S E R V I C E N O T E

87510A Gain-Phase Analyzer

Modification to fix unexpected spurious problem.

Figure 1. A3 Board Modification

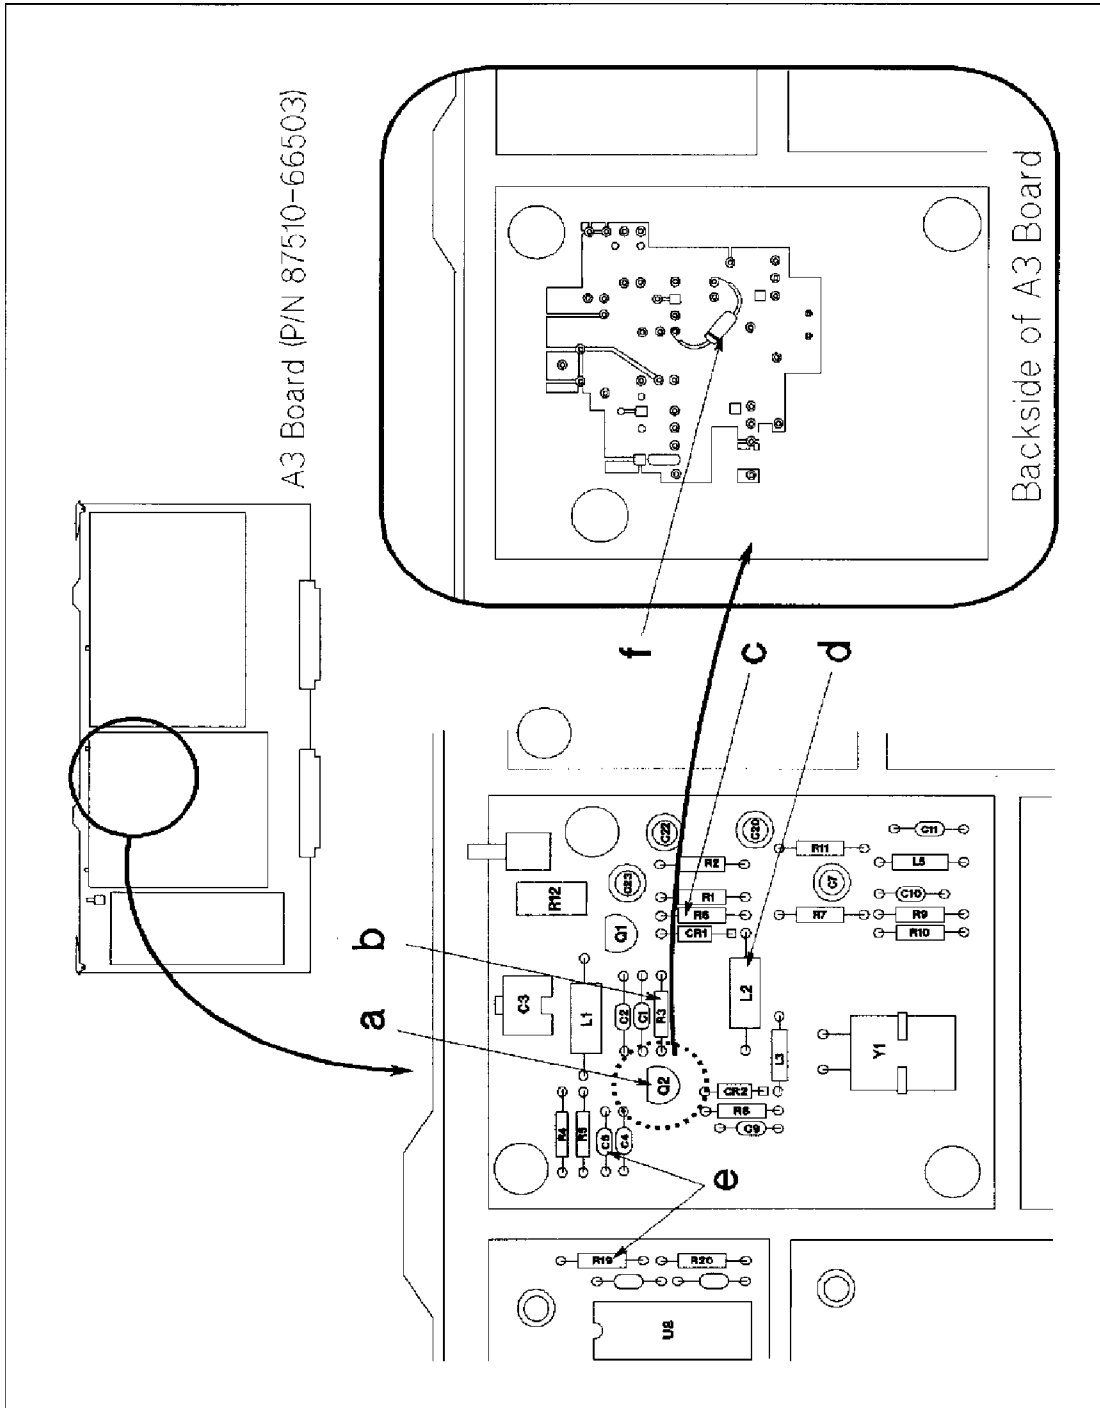
The 87510A may show the unexpected spurious response due to the parasitic oscillation of the source signal.

This is caused by the breakdown of A3Q2 transistor. This symptom can be confirmed using the following procedures:

1. Turn the 87510A off. Remove the top cover and the shield plate.
2. Remove the A3 board.
3. Modify the A3 board with referring Figure 1:
 - a. Replace the A3Q2 transistor (P/N 1854-1073) with the new one.
 - b. Replace the R3 resistor. 464 ohm --> 1 kohm (P/N 0757-0280)
 - c. Replace the R6 resistor. 464 ohm --> 316 ohm (P/N 0698-3444)
 - d. Replace the L2 inductor. 680 nH --> 470 nH (P/N 9100-3548)
 - e. Replace the location of C5 (0.01 uF, P/N 0160-4832) and R19 (215 ohm, P/N 0698-3441).
4. Perform the following adjustments:
 - 100 MHz VCXO Frequency
 - 1st IF Offset Osc Frequency
 - Fractional N Pretune CC
5. Reinstall the A3 board.
